# ANALYSIS OF SER DEGRADATION PARAMETERS

(COMMENT #40)

Cl 119 SC 119.2.5.3 P 162 L 17 # 40  
Ran, Adee Intel

# Baseline vs. scenario 1 (#3)

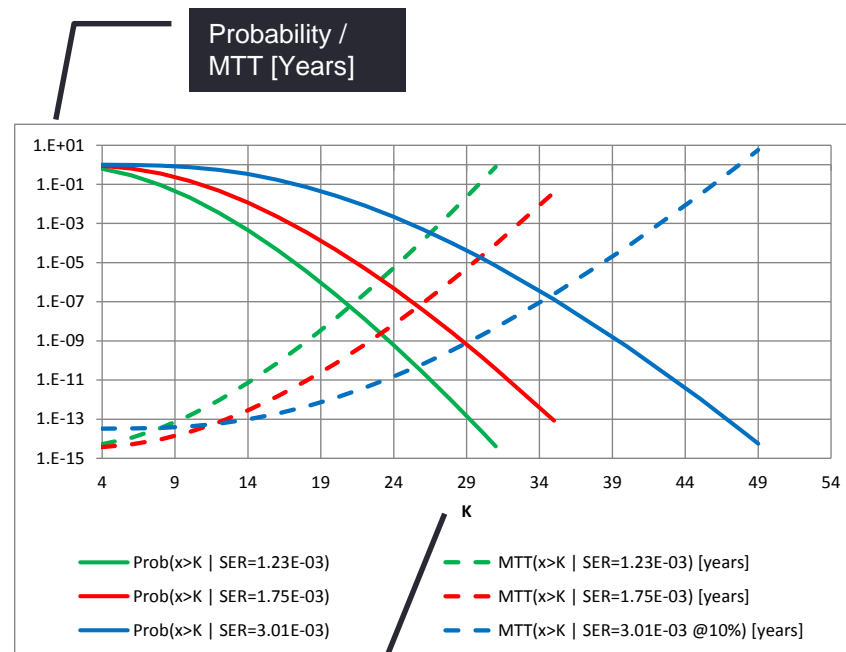
- Based on the curves, we can choose thresholds between 6000 to 8000
    - For example, FEC\_degraded\_SER\_assert\_threshold=8000 and FEC\_degraded\_SER\_deassert\_threshold=6000
    - A large distance between thresholds creates hysteresis and prevent noisy alerts (not analyzed here)
  - With assert threshold at 8000:
    - **SER=1.23e-3** or lower would “never“ create (false) alert
    - **SER=1.75e-3** or higher would cause immediate (true) alert
- ➔ Looks like a good combination of parameters
